TECHNICAL BULLETIN

212-23-218

MODEL AFFECTED: 212

SUBJECT: NEW TAIL ROTOR BLADE 412-016-100-111,
INTRODUCTION OF.

Figure 1 – Tail Rotor Blade 412-016-100-111 Installation

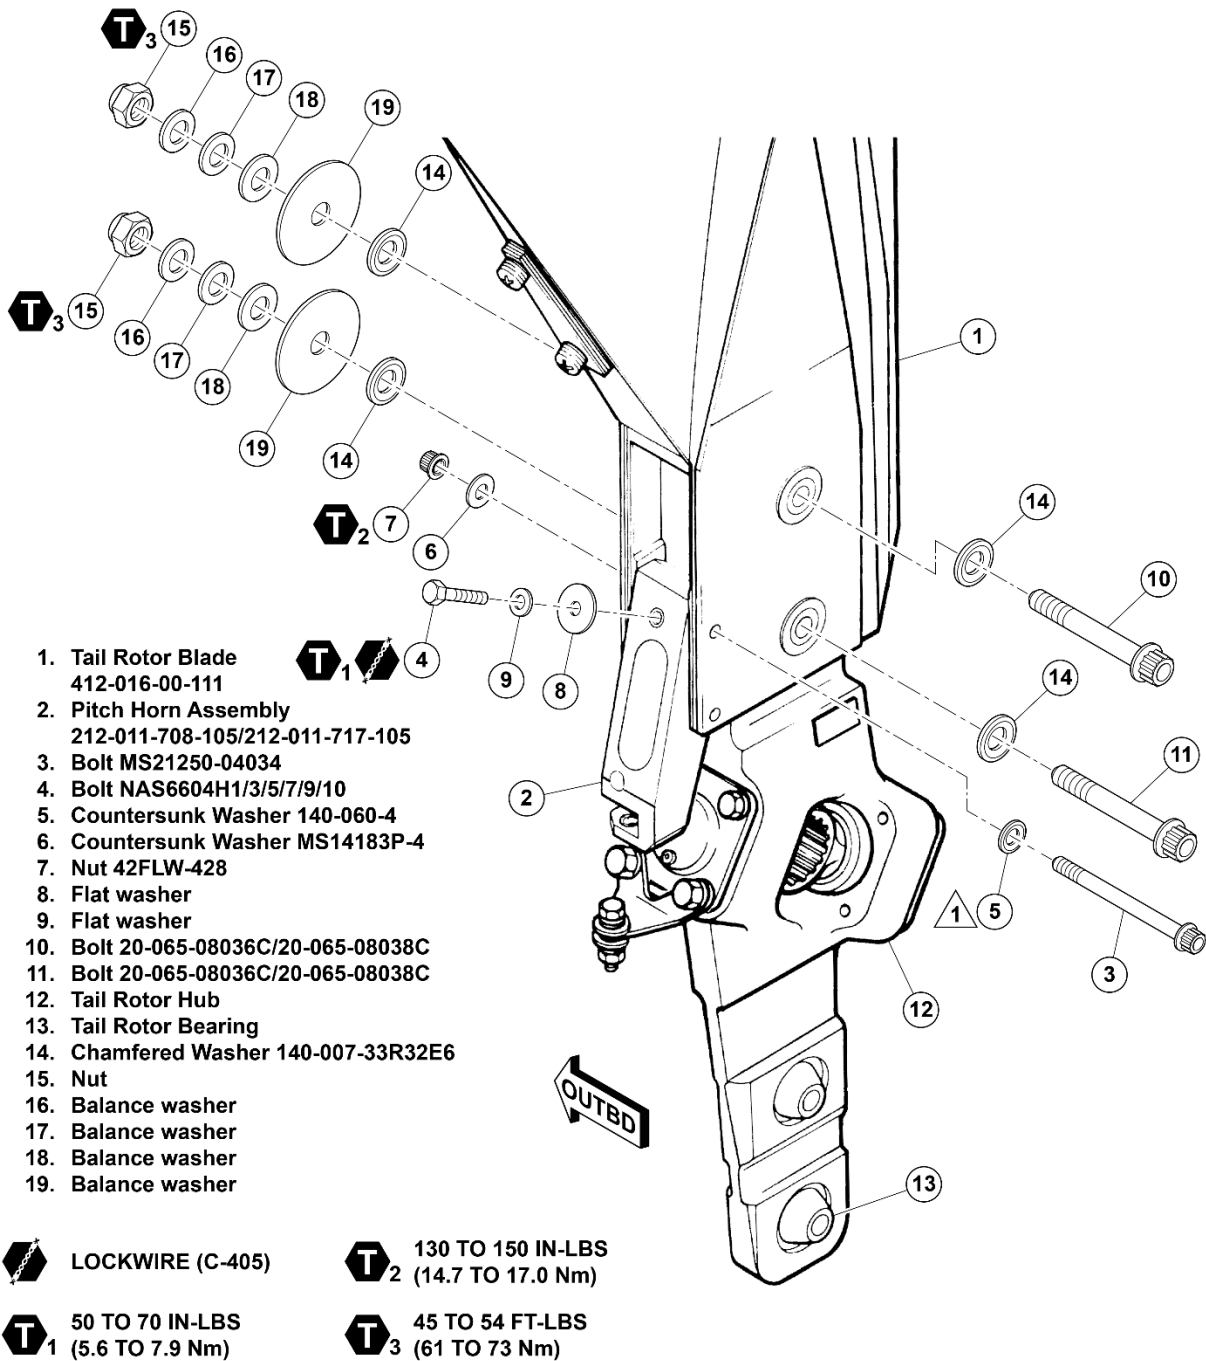
This bulletin provides instructions to install tail rotor blade 412-016-100-111 on the Model 212. This tail rotor blade assembly incorporates two fiberglass straps bonded to the interior upper and lower spar walls. The purpose of the fiberglass straps is to add structural redundancy in the event of a blade crack. This blade is differentiated by a new paint scheme and cannot be intermixed with the 212-010-750 tail rotor blade. With the new blade installation, a hardware change is also required.

Tail rotor blades 412-016-100-111 are heavier, and therefore cannot be mixed with the previous 212-010-750 series tail rotor blades.

4. Assemble the tail rotor hub and blade assembly with the new tail rotor blades (1, Figure 1) and hardware as below:
 - a. Install the tail rotor pitch horn (2) on each tail rotor blade (1) as follows:

- (2) Position the tail rotor pitch horn (2) between the blade grips.
 - (3) Install the two bolts (3), washers (5 and 6), and nuts (7), torque the nuts (7) 130 to 150 inch-pounds.

- (4) Install the bolt (4) and the balance washers (8 and 9), as required. Torque the bolt 50 to 70 inch-pounds. Secure the bolt to the tail rotor pitch horn (2) with lockwire (C-405).

- d. Align the tail rotor bearing (13) with the blade bolt holes. Install the bolts (10 and 11) and chamfered washers (14) with the nuts (15).
